BOARD OF ZONING APPEAL

BZA Application Form

BZA Number: 1188742

LOCATION OF PROPERTY: 514 Franklin St., Cambridge, MA

A-5.1

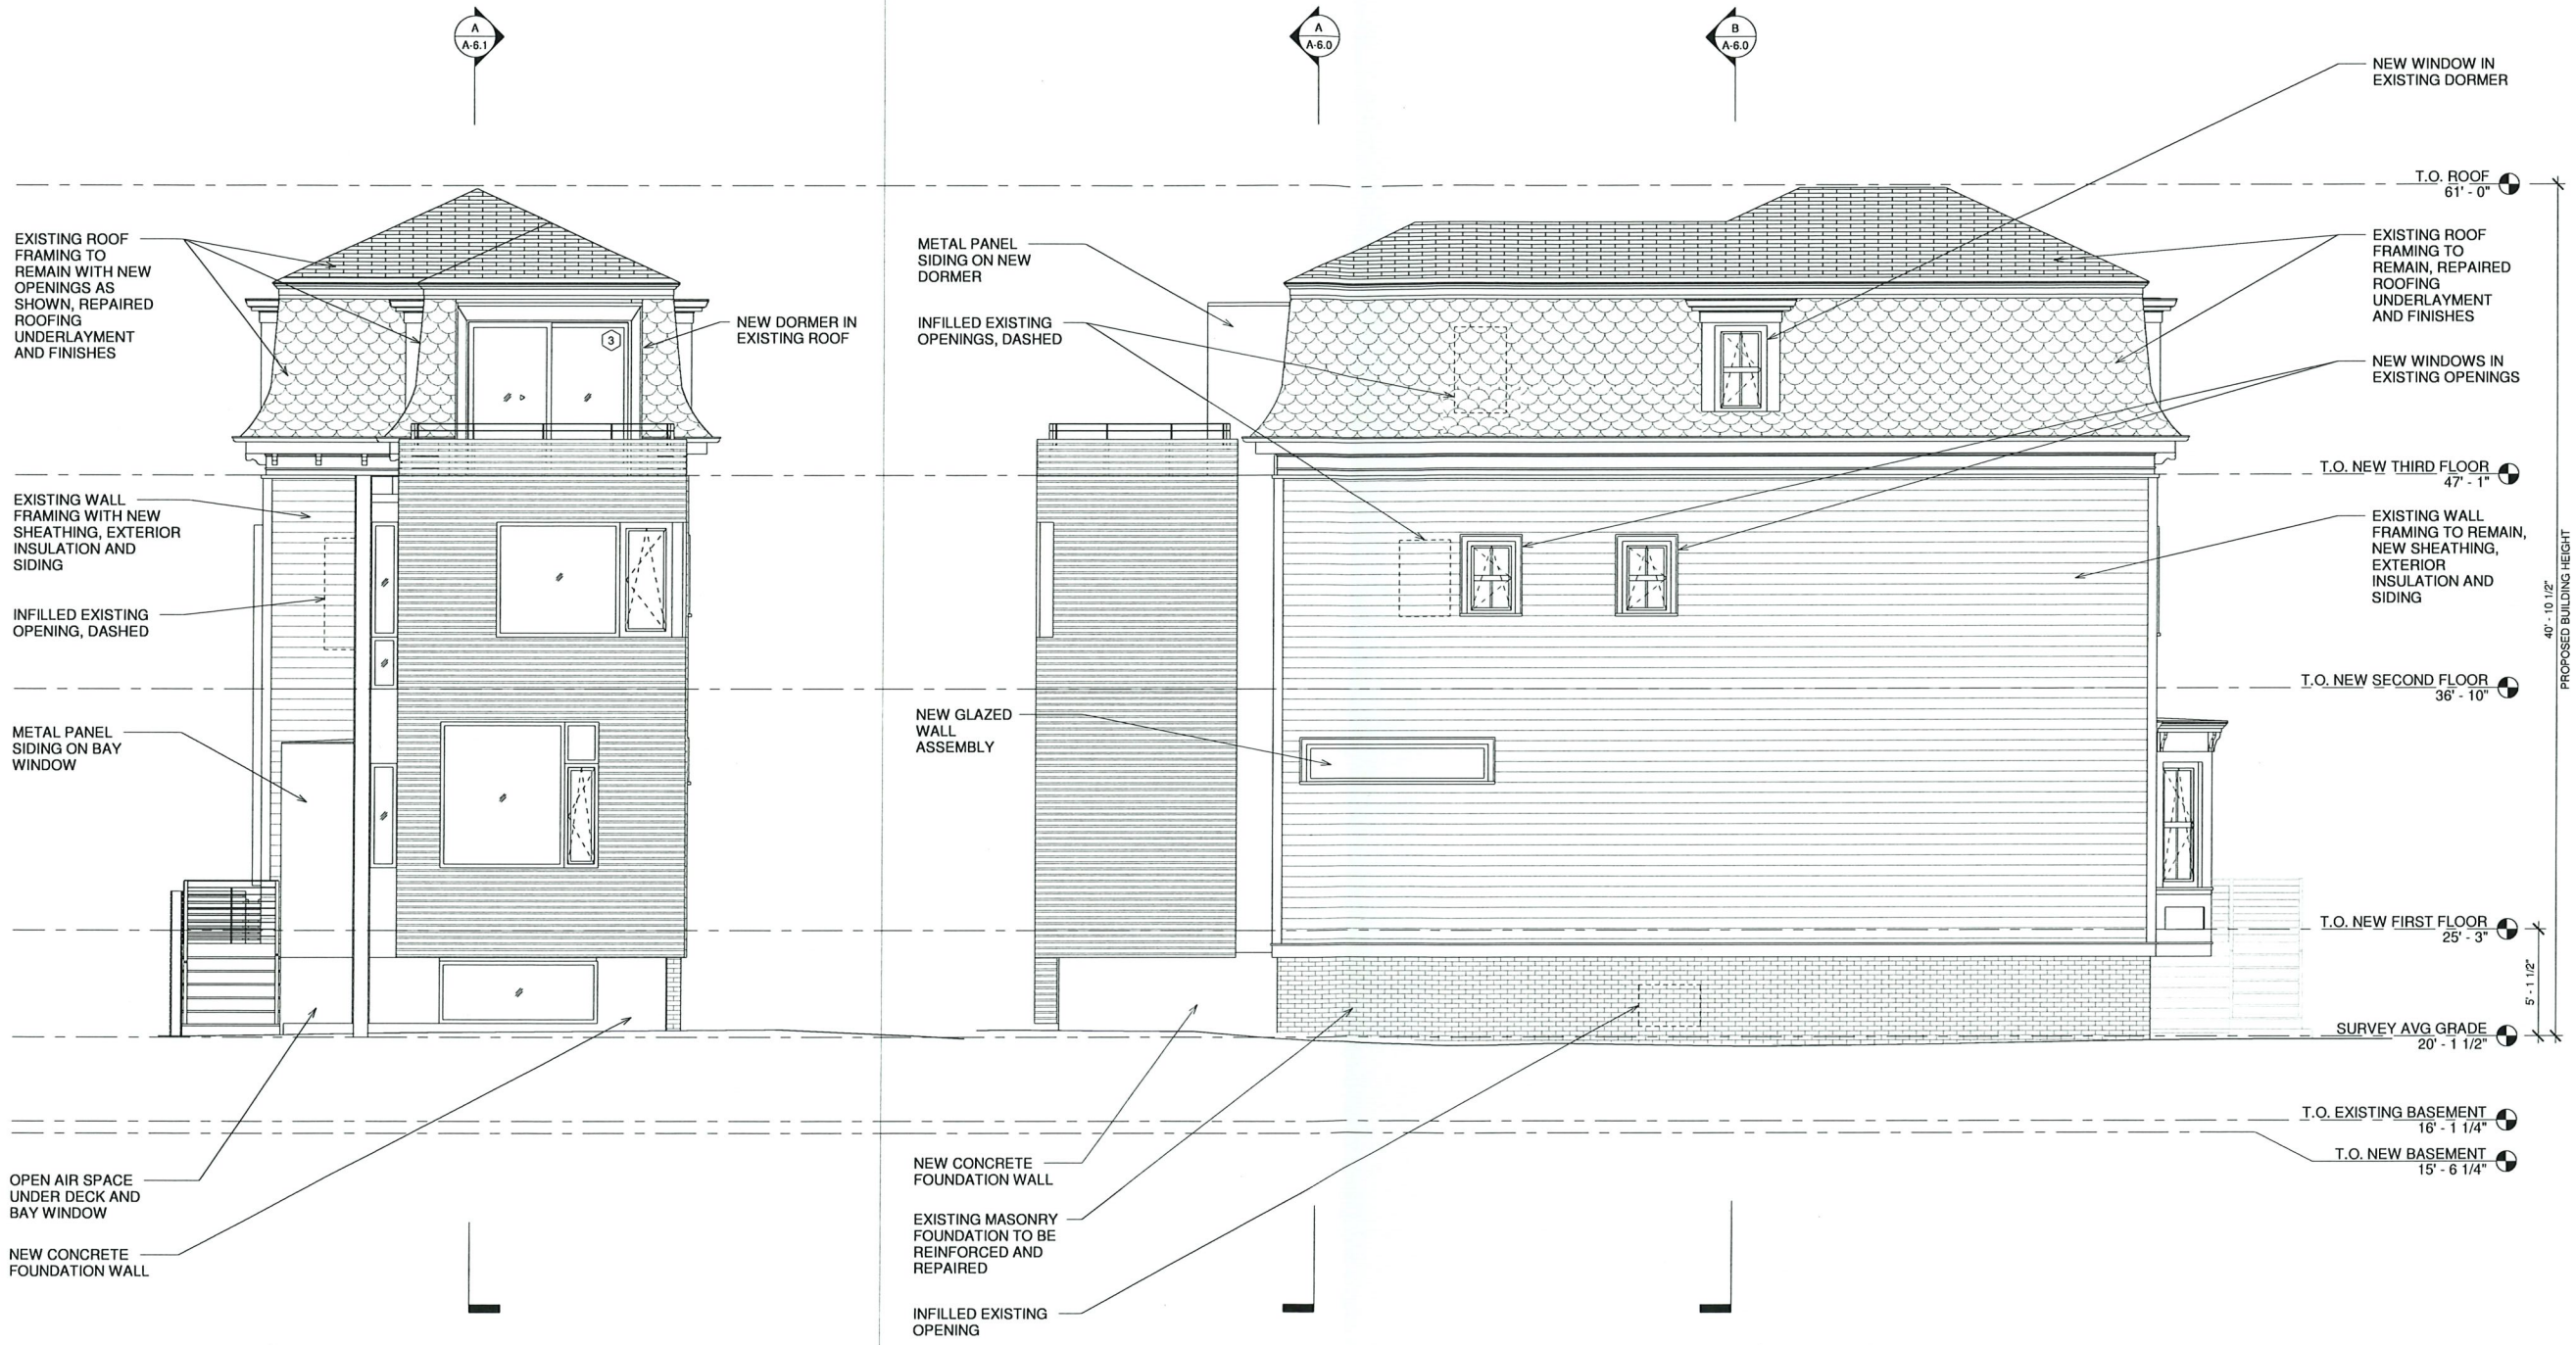
Attached please find a revised set of elevations in the above-captioned case reflecting a reduction in the proposed number of window openings on the non-conforming left side wall. A detailed description of the changes is set forth in the attached communication from the petitioners.

Figure 1: Our property will be enclosed by the existing garage/workshop and the new 3-story addition on the west side. Depriving it of air, light, and skyview.

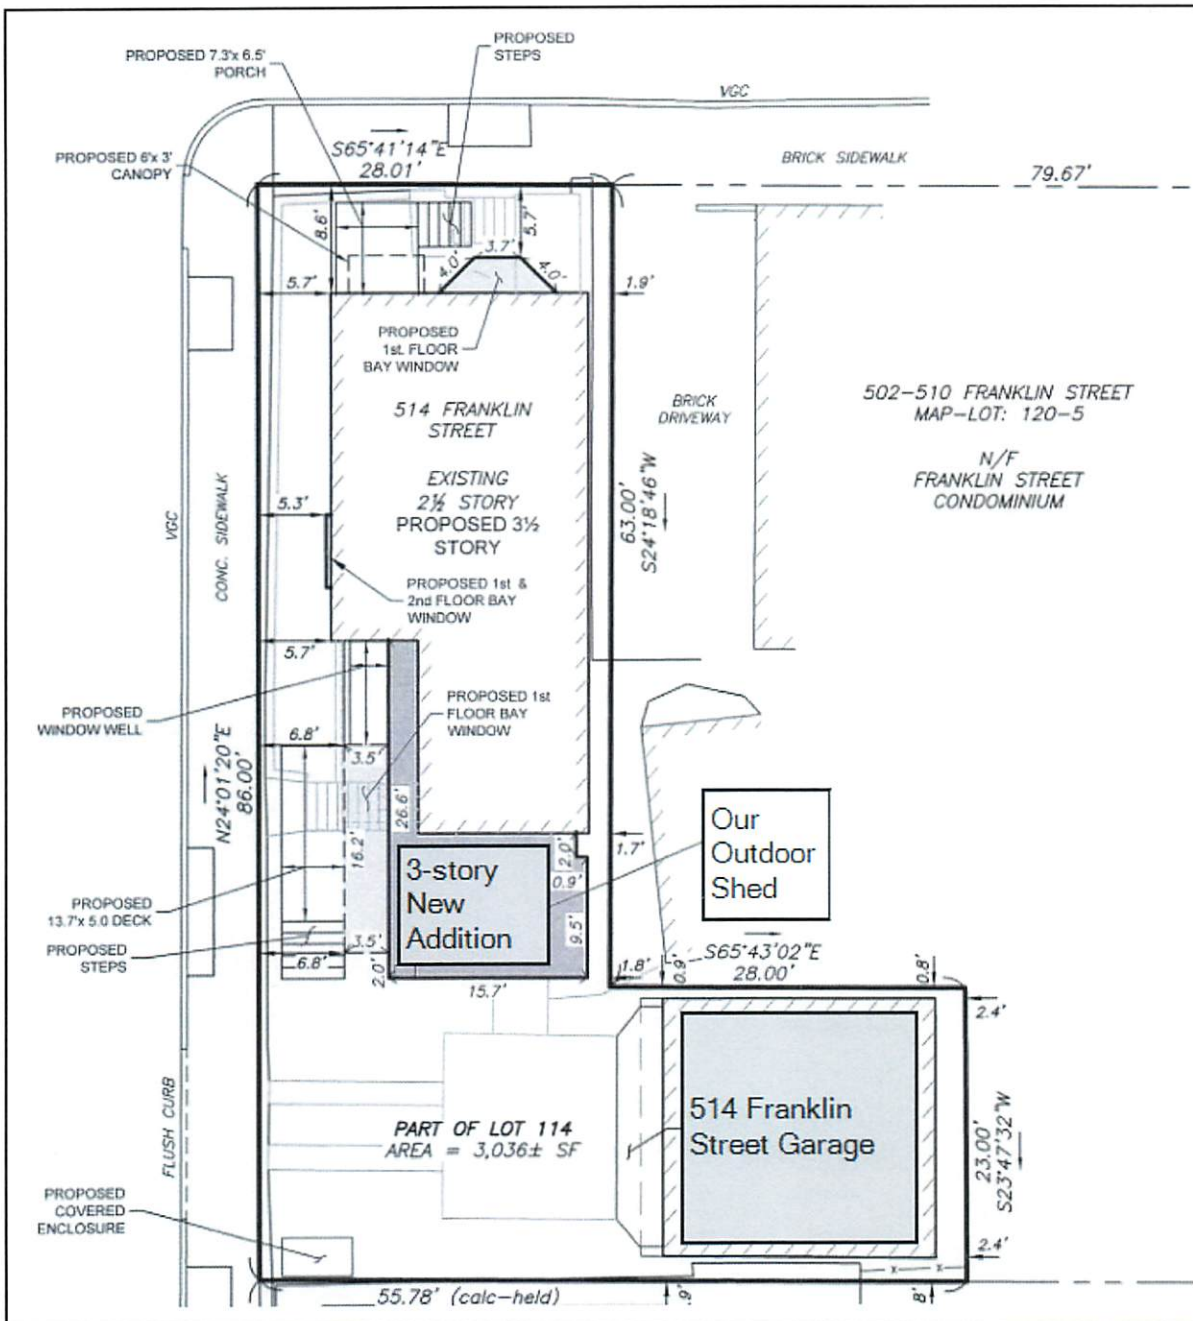
By placing a three-story structure only 1.7 feet from the shared property line and extending it substantially beyond the existing footprint, the proposal would create a lasting condition that materially constrains the reasonable future development of our property. We have long planned to rebuild and modernize our existing shed, and the recent zoning reforms provide additional flexibility for improvements to our home. The immediate presence of a three-story structure at this proximity would significantly diminish light, air, and sky exposure to our property, making such improvements substantially less practical and viable.

Figure. 4: Five windows on the wall 1.7 feet away from our property line

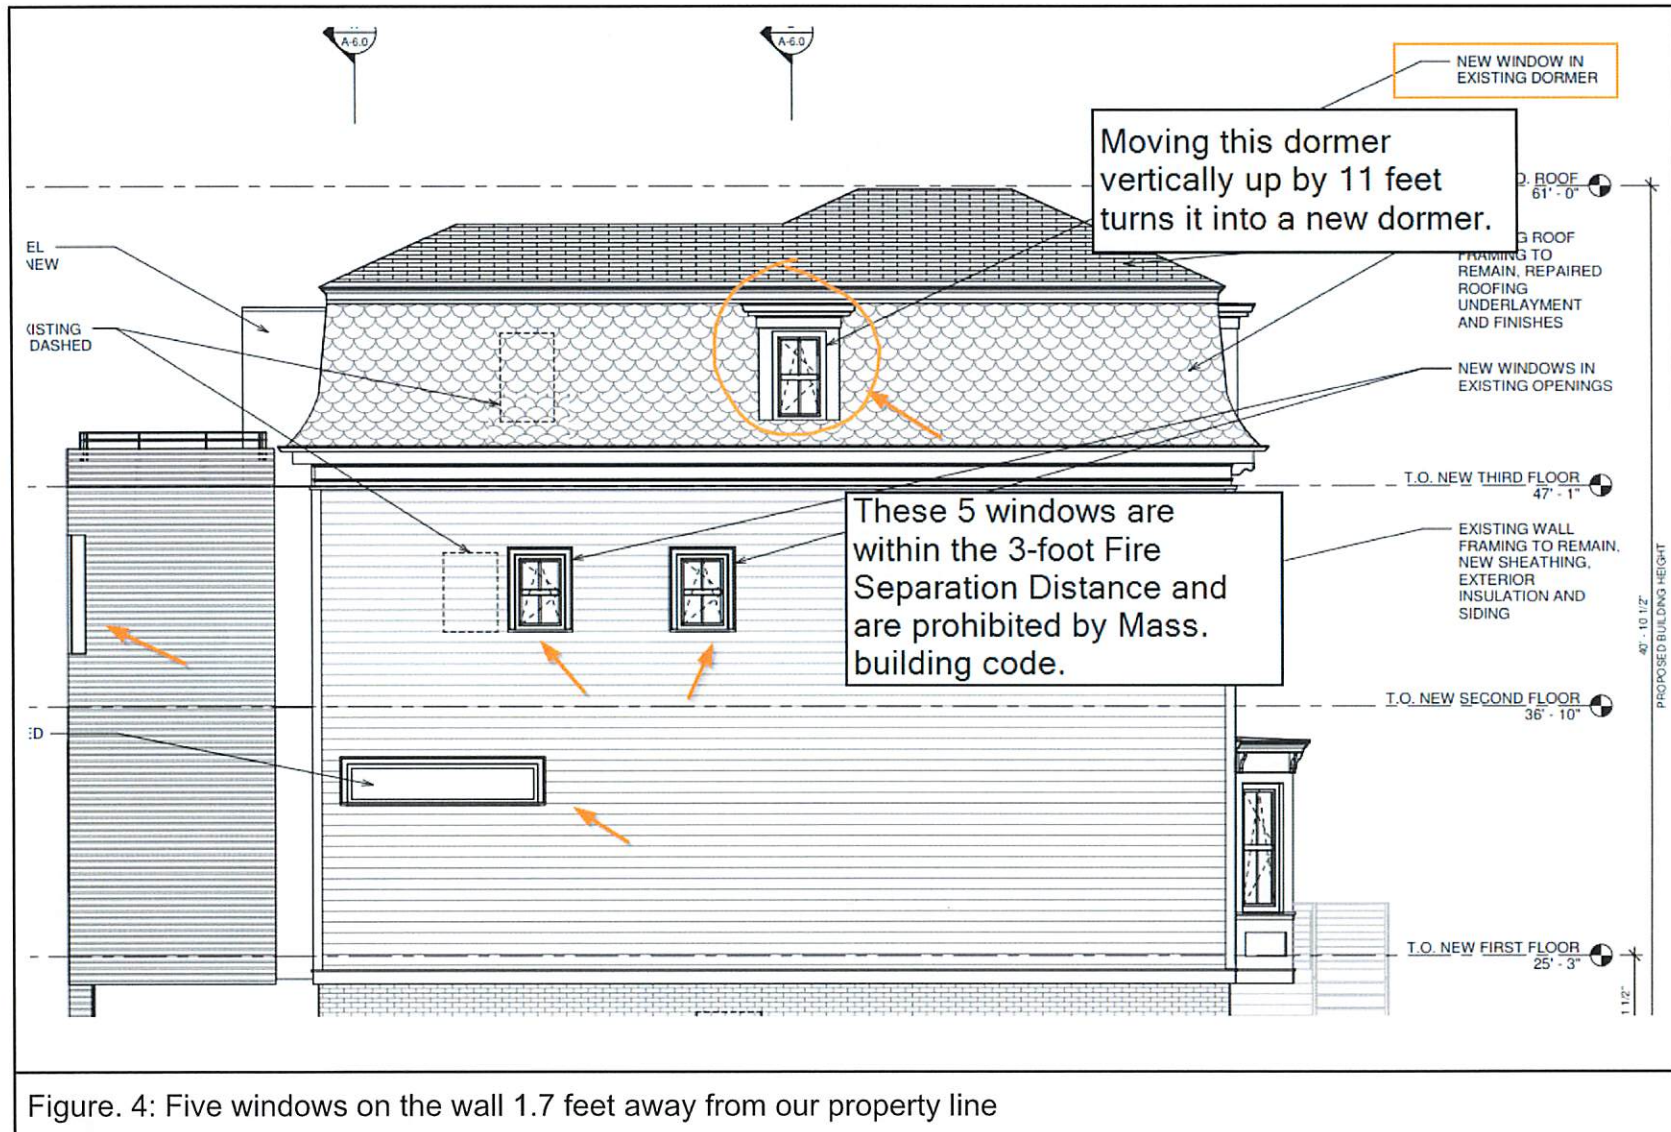
Under the Massachusetts State Building Code (780 CMR) governing building safety, exterior wall openings within three feet of a property line are subject to strict fire safety limitations. Based on the submitted plans, these windows appear to be new or materially altered, including a “new window in existing dormer” on the proposed third floor (see Figure 4). Such changes would eliminate any grandfathered condition and trigger full code compliance.

Figure 3. The Excavation pit was within the setback area in which relief has not been granted.

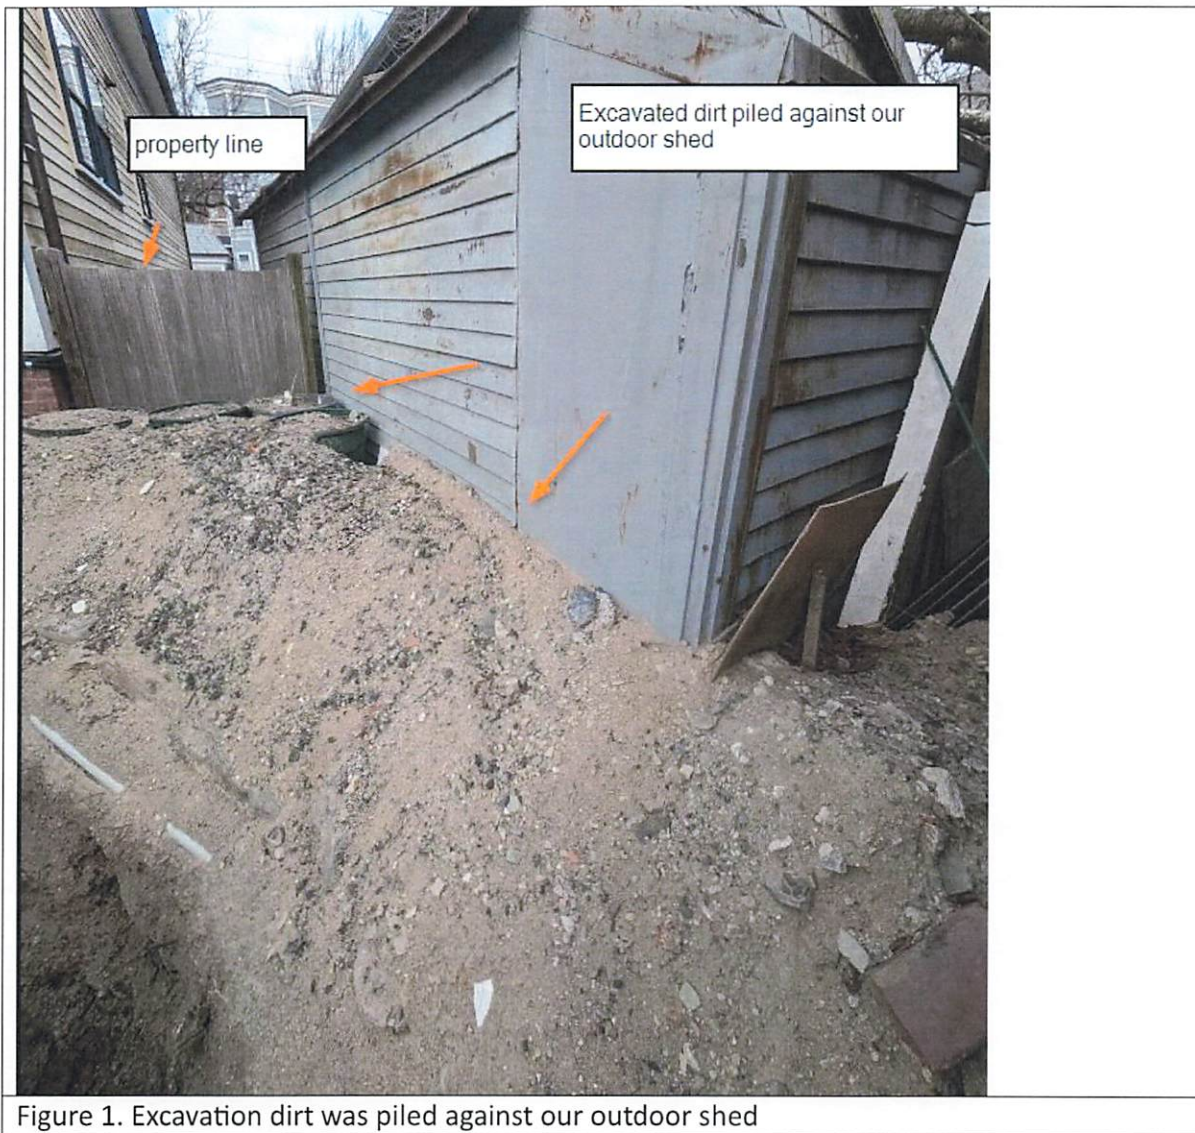
We note that this excavation lies entirely within the setback area where the proposed construction requires relief from this Board (Figure 3). We raise this issue not to litigate it here, but to explain why transparency and process have been of particular concern to us throughout our interactions with the applicants in connection with this request for discretionary relief.
